## **St Catherine's School Response to PAC questions**

This letter provides a response to the following questions raised by the Planning Assessment Commission relating to traffic matter associated with the St. Catherine's School development application (SSD 6339).

Drawing Title  
**Turning paths  
 Garbage vehicle  
 Entry**

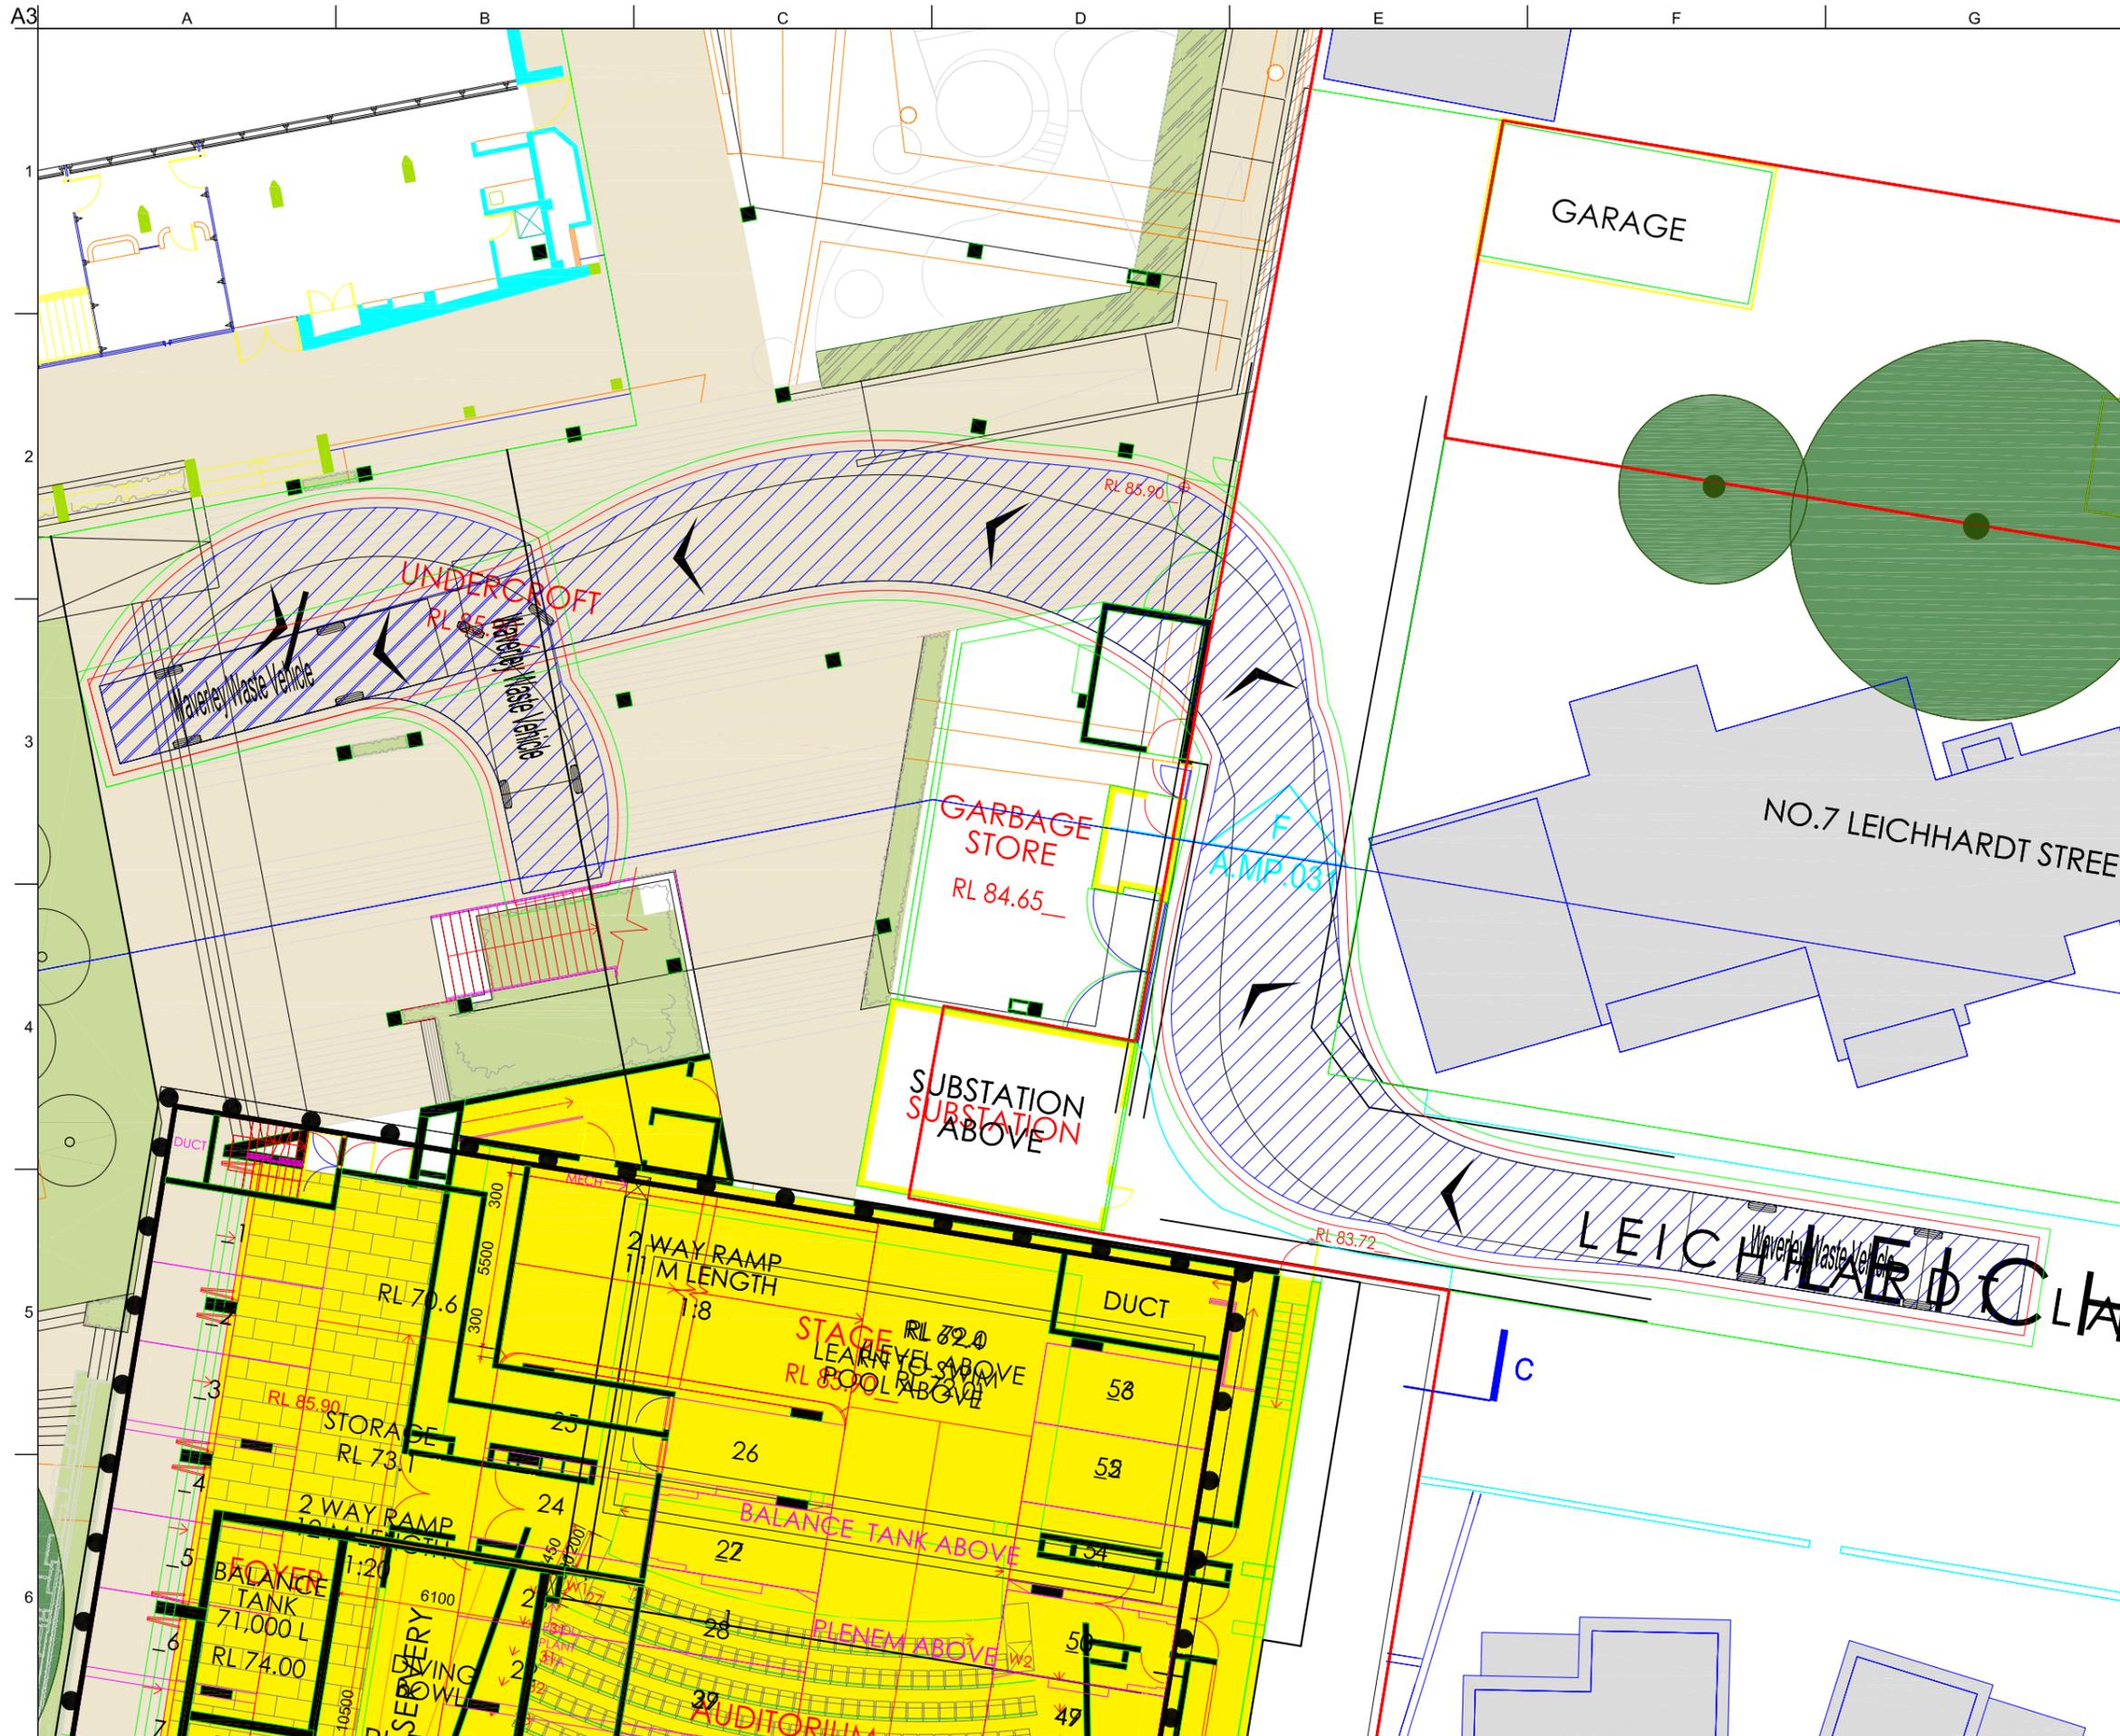
**The Commission has been advised that garbage trucks servicing the school are currently unable to turn around and must reverse back along Leichhardt Lane to exit. The Commission understands it should be possible to resolve this issue as part of this proposal. Is there any reason why garbage trucks servicing the site would not be able to enter and leave in a forward direction?**

Swept paths have been prepared for a typical council garbage truck to determine whether or not there is sufficient space for a truck to enter and exit the site in a forward direction in Leichhardt Lane.

SKT101 and SKT102 show the garbage truck entering and exiting the school site in a forwards direction from Leichhardt Lane. Both directions of travel require a very wide gate opening to be provided and require the truck to traverse approximately 40m into the site. The truck also needs to cut the corner in Leichhardt Lane and traverses across private property to execute the turn. The swept paths demonstrate that the typical truck employed by Waverley Council is too large to manoeuvre through the bend on Leichhardt Lane without imposing on private property. These findings are consistent with advice provided by Geoff Garnsey.
